ENGINEERING BULLETIN

Ref Document No.	EB15002	Issue No.	2
Subject	Load Frame Pins		
Release Date	3 rd September 2015

Purpose – Advise COALTRAM® owner's of a revision to the recommended replacement intervals for load frame pins and split cap bolts.

Applicability – COALTRAM® models CT10, CT10LP and CT08

Figure 1: Location of pin failure

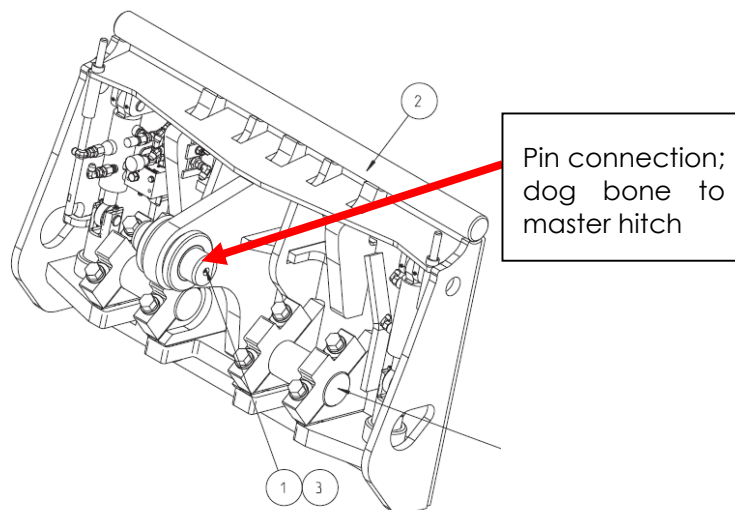
The pin failure occurred on a Coaltram CT10 reported to have completed over 13,000 hours of operation. The pin that failed was at the connection between the dog bone and master hitch as shown in figure 1 below. This pin is the same used across all Coaltram CT10 master hitch's; QDS, KAT, RAS

Figure 3: Original and revised pin designs

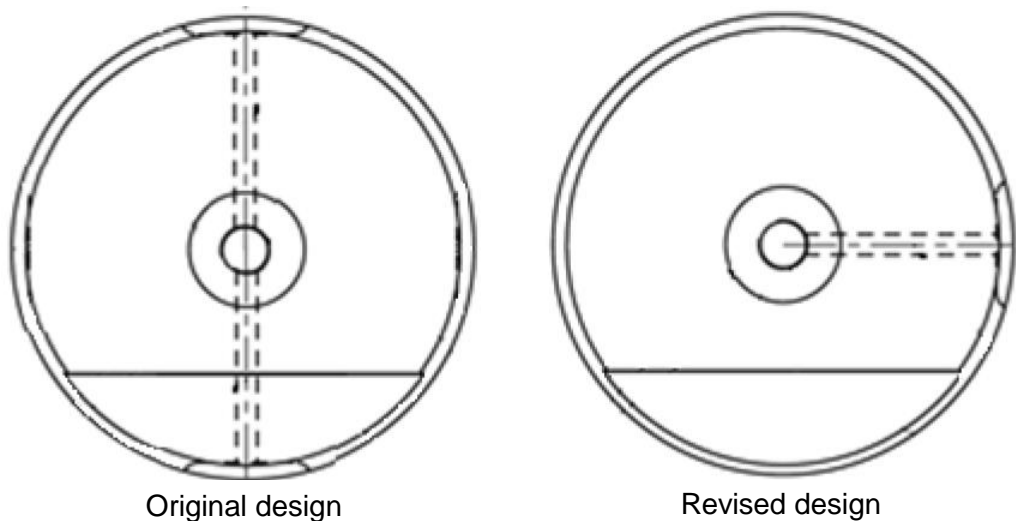
The pin failed due to fatigue with cracks beginning from the grease points (see figure 2). The original design of the pin had the grease porting drilled through the whole diameter of the pin and the orientation of the grease port was located at the position of maximum bending stress. The design of the pin has been revised, re-orienting the grease porting to the position of least bending stress and the porting is now drilled to exit on one side of the pin only (see figure 3).

Figure 4: CT10 Crowd Linkage

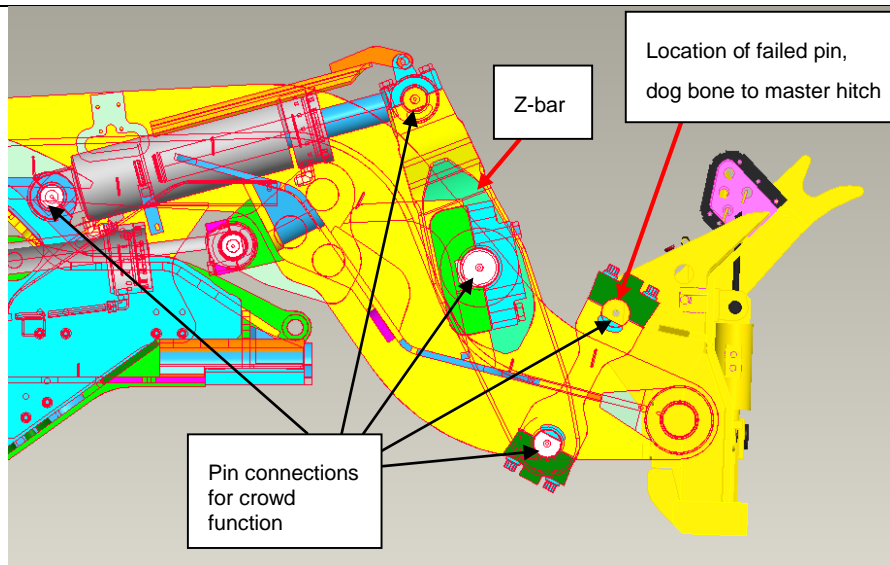
The Coaltram CT10 has a different crowd mechanism to the Coaltram CT08 and CT10LP vehicles. The CT10 crowd cylinder attaches to and operates through a Z-bar arrangement using additional linkages and pins to attach to the master hitch. The CT08 and CT10LP crowd cylinder connects directly to the master hitch. The differences are illustrated in figure 4 and 5 below. There has not been any recorded failures of pins on the CT08 or CT10LP vehicles.

1. CT10 - 8,000 hour service:
 - a. Crowd cylinder pins should be ultrasonic tested for cracking and inspected for wear. This includes all pins between the crowd cylinder and attachment to the master hitch. If the pins are **not** ultrasonic or non-destructive tested, they should be replaced.
 - b. **IMPORTANT** - If ultrasonic testing reveals grease porting drilled all the way through the diameter of the pin, the pin should be replaced.
 - c. All split cap bolts used for retaining pins relating to master hitch crowd function should be replaced. (Split cap bolt kit part number 5520009362).

2. CT10 - 12,000 hours:
 - a. Ultrasonic testing of all pins for cracking and inspection for wear. If Ultrasonic testing is not completed, PPK recommend replacing all pins.
 - b. Replacement of all split cap bolts, excluding crowd cylinder split cap bolts. (Split cap bolt kit part number 5520009704)
3. CT10 - 16,000 hours:
 - a. Replace all connection pins. (Pin kit part number 5520009581 – kit contains pins and seals. Bushes should be inspected and replaced as required).
 - b. All split cap bolts used for retaining pins relating to master hitch crowd function should be replaced. (Split cap bolt kit part number 5520009362).
4. Follow PPK service sheets for all other recommended maintenance.
